MONTGOMERY COUNTY HISTORIC PRESERVATION COMMISSION
STAFF REPORT

Address:	29 West Irving Street, Chevy Chase	Meeting Date:	7/28/2021
Resource:	Contributing Resource (Chevy Chase Village Historic District)	Report Date:	7/21/2021
Applicant:	Allison and Peter McDonnell (Case Design & Remodeling, Agent)	Public Notice:	7/14/2021
Review:	HAWP	Tax Credit:	No
Permit Number:	953229	Staff:	Michael Kyne

PROPOSAL: Fenestration alterations and alterations to the rear elevation

Fig. 1: Subject property.

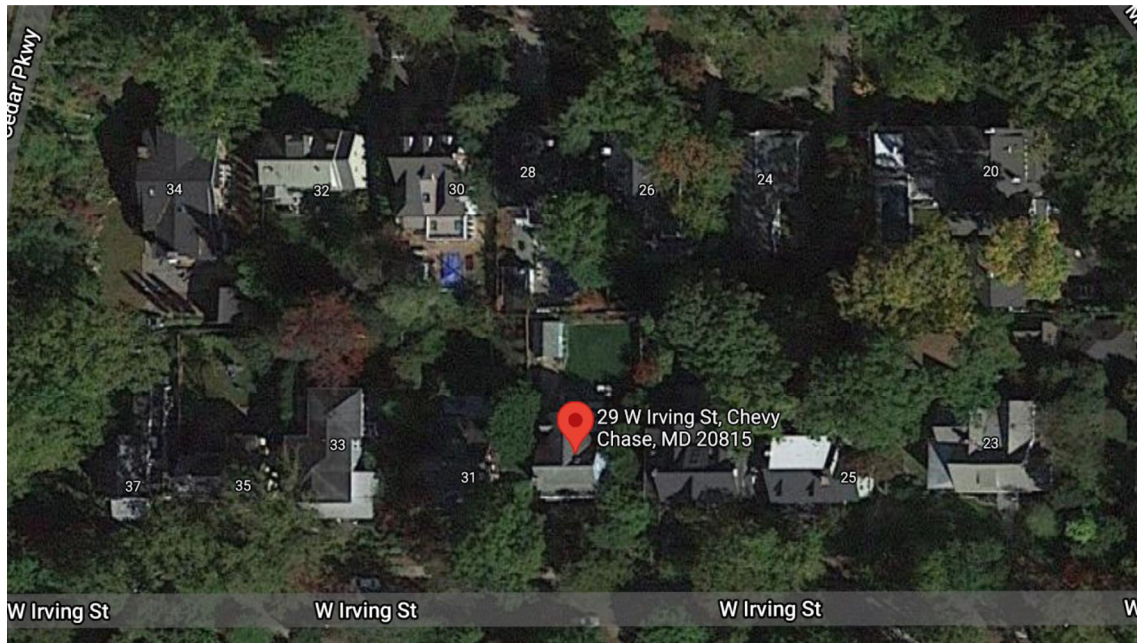
The subject property is a c. 1892-1916 Dutch Colonial/Regency-style Contributing Resource within the Chevy Chase Village Historic District. There is a c. 1990s addition with open first floor porch at the northwest (rear/left, as viewed from the public right-of-way of West Irving Street) corner.

Staff supports the applicants' proposal, finding it consistent with the *Guidelines*. The proposed porch enclosure and fenestration alterations are primarily at the rear, where they will be negligibly visible from the public right-of-way, at best. Further, these alterations will only affect the non-historic 1990s addition. Accordingly, staff finds that these alterations should be subject to lenient scrutiny. The *Guidelines* state that lenient scrutiny "means that the emphasis of the review should be on issues of general massing and scale, and compatibility with the surrounding streetscape, and should allow for a very liberal interpretation of preservation rules. Most changes should be permitted unless there are major problems with massing, scale and compatibility." Staff finds that the proposed porch enclosure and fenestration alterations will not impact the massing, scale, or compatibility of the subject property with the surrounding streetscape.

Staff recommends that the Commission **approve** the HAWP application under the Criteria for Issuance in Chapter 24A-8(b) (1), (2), and (d), having found that the proposal is consistent with the *Chevy Chase Village Historic District Guidelines* identified above, and therefore will not substantially alter the exterior features of the historic resource and is compatible in character with the district and the purposes of Chapter 24A;

Existing Rear Exterior Elevation-1990's Addition
Scale: 1/4" = 1'-0"

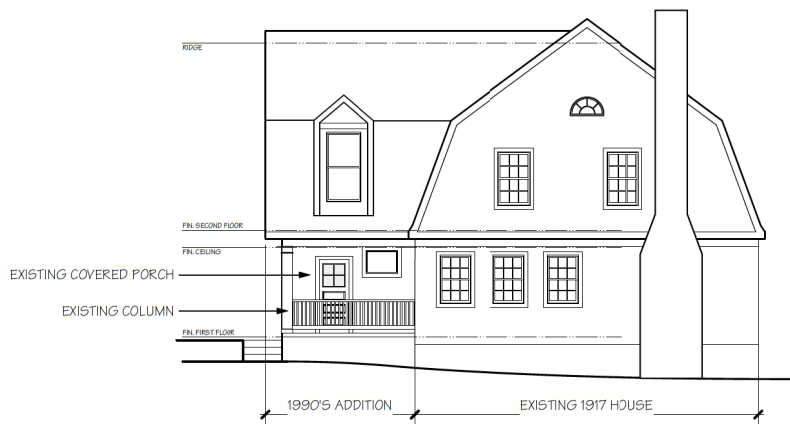
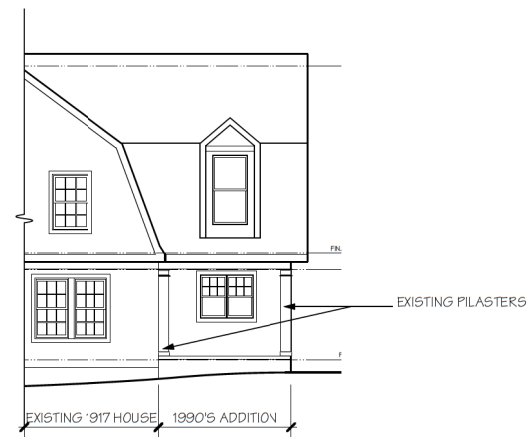
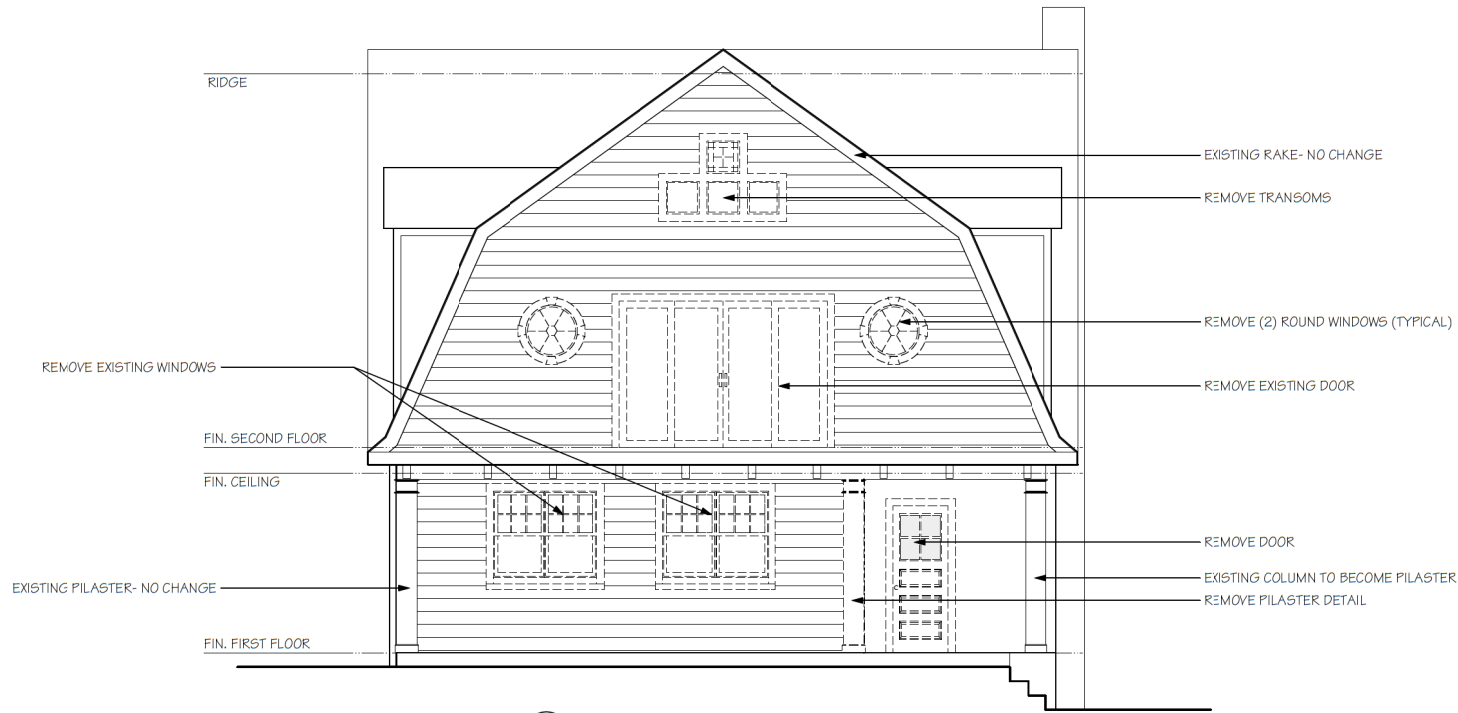
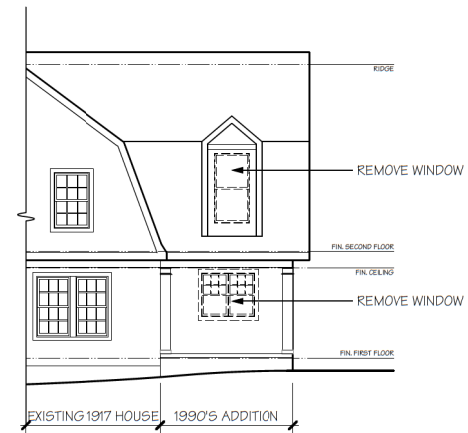
- Enclose the porch at the northwest (rear/left) corner of the 1990s addition.
 - The enclosure will be finished with wood lap siding, with a single-lite aluminum-clad French door on the rear elevation and PVC pilaster/corner boards to match the existing.

- Replace the two paired 6-over-1 double-hung windows on the first floor, rear elevation of the 1990s addition with single lite aluminum-clad French doors.

- Replace the door unit on the second floor, rear elevation of the 1990s addition with two 6-over-6 aluminum-clad double-hung windows.
 - The proposed windows will have permanently-affixed 7/8" interior and exterior muntins with internal spacer bars.

- Remove two round windows on the second floor, rear elevation of the 1990s addition.
- Replace the gable windows on the rear elevation of 1990s addition with a decorative, non-venting oval louver.

- The louver will be constructed from molded polyurethane.
- Replace the 1-over-1 double hung window in the dormer on the east/right side of the 1990s addition with a fixed 6-lite aluminum-clad transom window.

- Replace the paired 6-over-1 double hung window on the first floor, east/right elevation of the 1990s addition with a single 4-over-4 aluminum-clad double hung window.

- The proposed window will have permanently-affixed 7/8" interior and exterior muntins with internal spacer bars
- Install one new 6-over-6 aluminum-clad double-hung window on the second floor, west/left elevation of the historic house.
